January 11, 2019

All Customers who are currently using the UWE-12/10-Q12xxx-C DC-DC converter

Product Change Notification:

Original Design

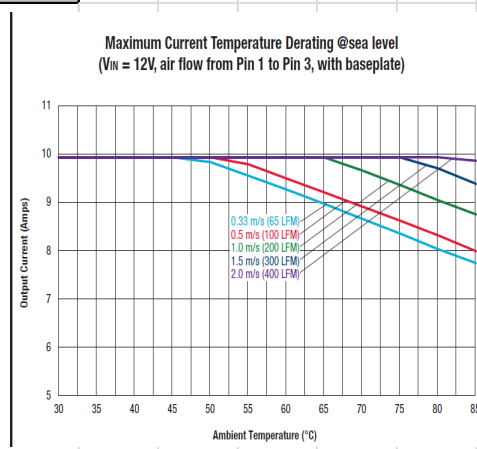
Parts that are Rev A – D are the original design, Rev E is the new-redesigned version (as shown in product label details below ;) In the upper right hand corner of the product label (BOM) is the current revision of the Bill Of Materials. This will identify the new design vs. the original design. We have also included a table that will highlight some of the major specifications/improvements of the converter. Please, refer to attached comparison table.
